Hastings Sierra Leone Friendship Link

SANITATION PROJECT

REVIEW

FEB 26

GRAFTON MODEL BAPTIST

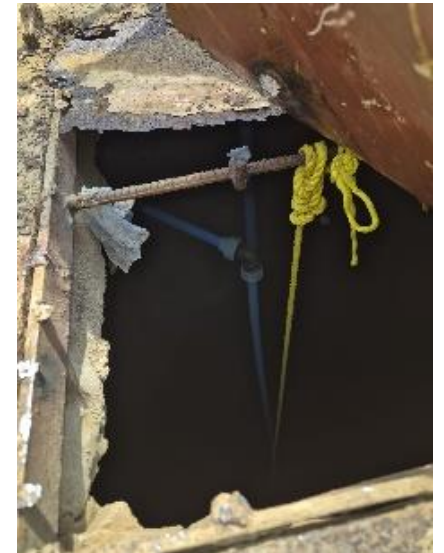
While we were originally informed that everything was working satisfactorily, there were multiple issues.

- Local vandalism had resulted in the hand pump being broken and removed.
- No access to mains power rendered the submersible pump useless.
- Exposed cabling was left by the well to allow a generator to be attached to run the pump. As they do not have generator, they claim to periodically borrow one. This seems unlikely, given the frequency they would need to fill the tank.

Water was extracted using a rope and bucket, demonstrating it is not dry yet which is often the case, even early in the dry season.

Several members of the school leadership team were present and expressed that while there were issues as described above, water was not their primary concern. A bigger problem was with the community and lack of security. Severe issues with large areas of school ground being used as a rubbish dump, traffic encroaching on what should be safe space for children, and vandalism/damage to school farm and school property. We have been advised that they have requested assistance with a boundary wall for some years. In addition, following flooding in the rainy season, one of the toilet blocks has had to be demolished for safety. There was disagreement between the contingent as to which should be prioritised, toilets or security. Water was a distant 3rd place!
